RE: REQUEST FOR MINOR CHANGE & EXTENSION TO CURRENCY PERIOD IN ACCORDANCE WITH S81 & S86 OF THE *PLANNING ACT 2016* – DEVELOPMENT APPROVAL UPON LAND AT 97 SWANN ROAD, TARINGA QLD 4068, 7 & 9 BURNS STREET AND 62 RENNIE STREET, INDOOROOPIILLY QLD 4068 (COUNCIL REF: A006847313)

MINOR CHANGE APPLICATION

Figure 3: Approved & Proposed Lower Ground 04 Floor Plans

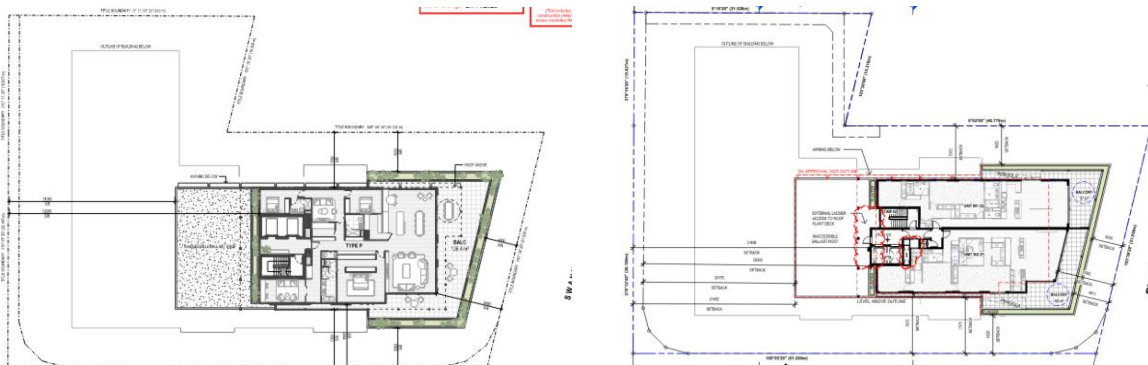
- Reduced car park widths from 2.5m or 2.6m to 2.4m, due to lift shaft placement;
- One car park space reduced in width from 2.6m to 2.3m, designated as a small car space;
- Removal of pad mounted transformer from the Rennie Street frontage;
- Additional booster cabinet relocated to Rennie Street frontage;
- Minor internal reconfiguration of bin rooms, services and building cores;
- Removal of 5 bicycle spaces for residents;

Figure 4: Approved & Proposed Level 05 Floor Plans

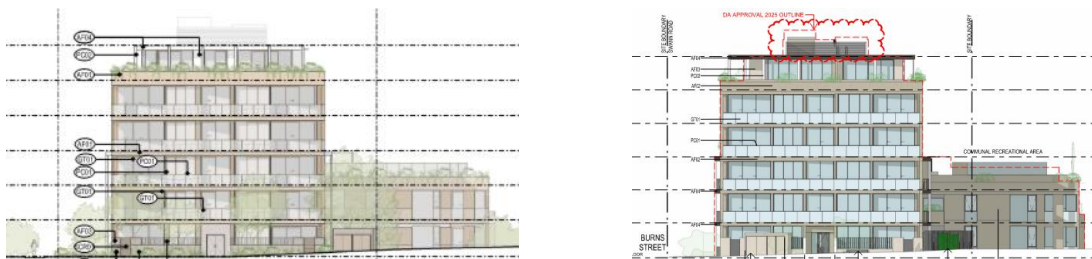
- Conversion of the approved penthouse unit into two units;
- Partial enclosure of approved balcony space as internal space for each unit;
- Corresponding increase to roof extent;
- Marginal reduction in planter width;
- No change to setback from Swann Road to planter (OMP);

Through the design review process, an opportunity has arisen to refine the approved dwelling product by reconfiguring the approved penthouse dwelling into two three bedroom dwellings. This enables the development to accommodate one additional household and provides a more diverse and comparatively more affordable housing product than the currently approved penthouse dwelling. The change therefore represents an opportunity to improve the efficiency and housing diversity of the approved development, while generally retaining the established building envelope and overall architectural intent.

The reconfiguration of the penthouse necessitates corresponding changes to the private open space arrangements and results in a partial enclosure of the approved balcony space. This reduces the Swann Road frontage setback from 8.5m to approximately 7.5m to the wall. The approved planter width is also reduced by approximately 300mm, resulting in a setback of approximately 4.8m to the revised planter arrangement. Importantly, the proposal maintains the approved 4m setback to the outermost projection, being the external face of the planter, with sufficient width retained to accommodate substantial deep planting along the Swann Road frontage.

Figure 11: Proposed Communal Open Space Area

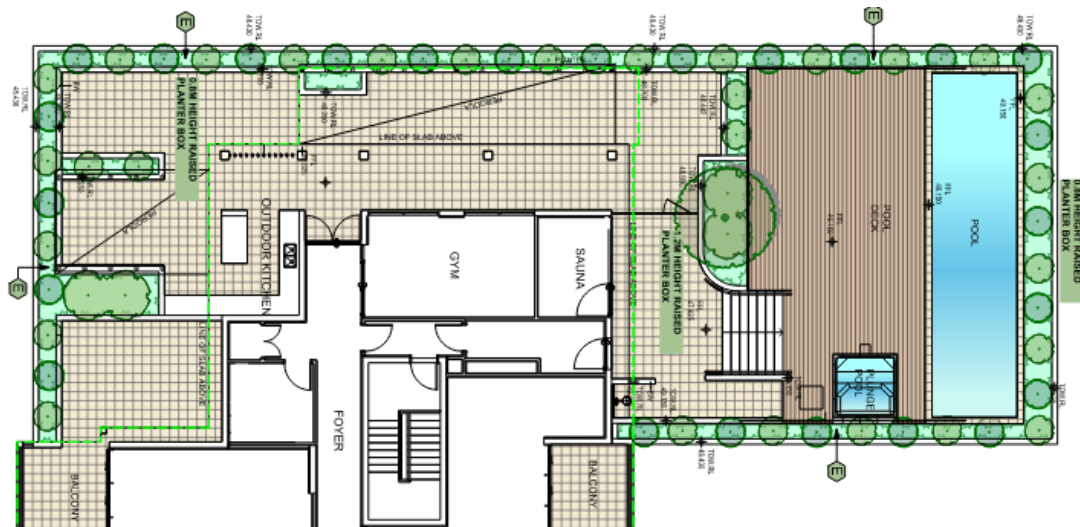
As part of the proposed changes, the communal open space has been refined to enhance the amenity provision of functional areas, including gym, sauna, pool and outdoor kitchen, with consequential amendments to solid concrete and pergola roofed extents.

Whilst the planter widths around the perimeter of the communal open space are reduced in parts, the enclosed landscape concept plan prepared by *Mark Baldock Landscape Architect* (Ref: 2707) demonstrates 0.8m-1.2m high planter boxes accommodating species capable of reaching up to 0.9m height at maturity, which is considered to achieve sufficient shade planting and enhance the microclimate for the residential units, particularly on the western façade. An extract of the proposed communal open space from the revised landscape concept plan can be seen in below.
